# UNITED STATES PATENT AND TRADEMARK OFFICE

APPLICATION NO.	FILING DATE	FIRST NAMED INVENTOR	ATTORNEY DOCKET NO.	CONFIRMATION NO.
10/507,177	09/10/2004	Michael Maurice Butler	101709.55374US	4396

<b>Office Action Summary</b>	<b>Application No.</b> 10/507,177	<b>Applicant(s)</b> BUTLER, MICHAEL MAURICE	
	<b>Examiner</b> Dan Pihulic	<b>Art Unit</b> 3662

**Figure 3**

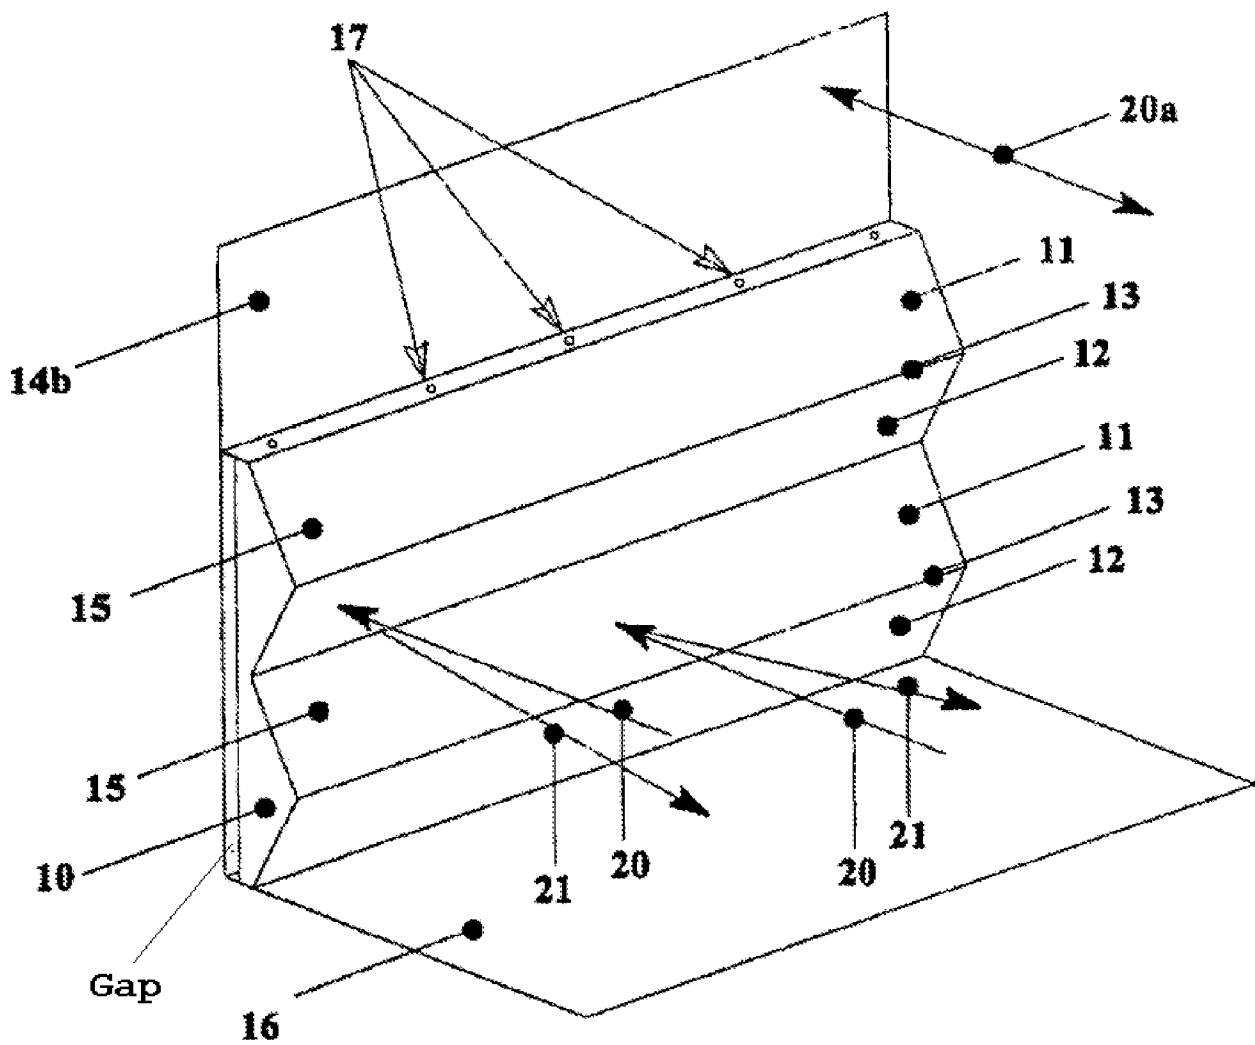
1. Applicant's arguments filed 2-3-2009 have been fully considered but they are not persuasive with regards to claim 11. Figure 3 of the WO0109562 reference clearly shows a Gap (as indicated by the examiner) between the side of the object (14b) and the array (10).
